## Product Change Notice (PCN)

**PCN Number:** PCN-0460231R-01 **To Our Customers:**

**Product(s) Affected:** TB009-508 series

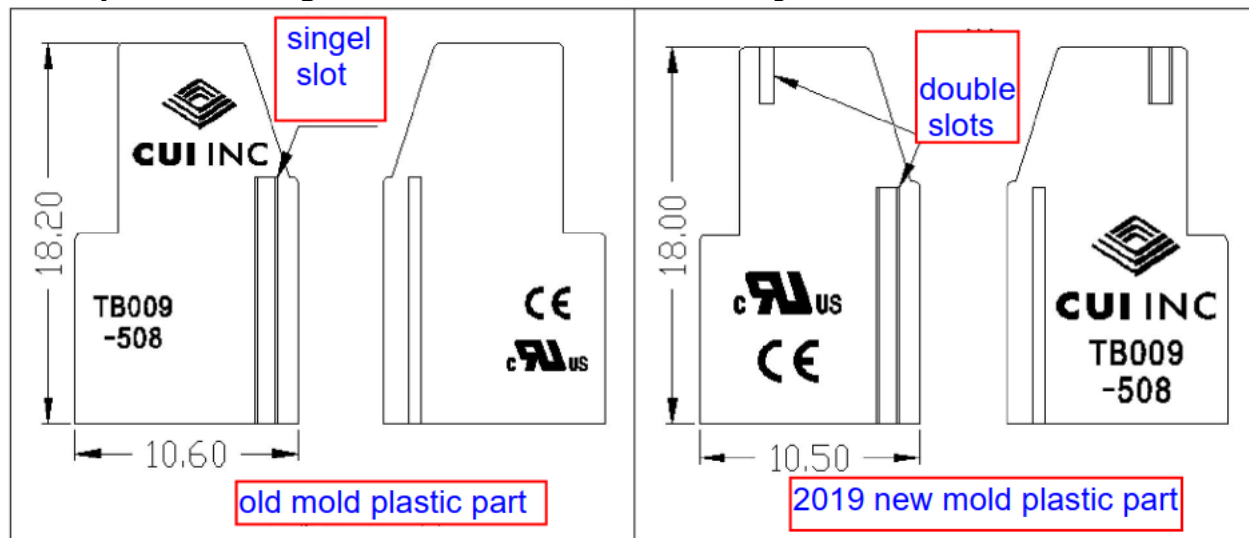
**Description of Change:** Additional slot for ease of configuration as shown below:

**Additional Information:** Products using the old mold cannot be connected to products using the new mold.
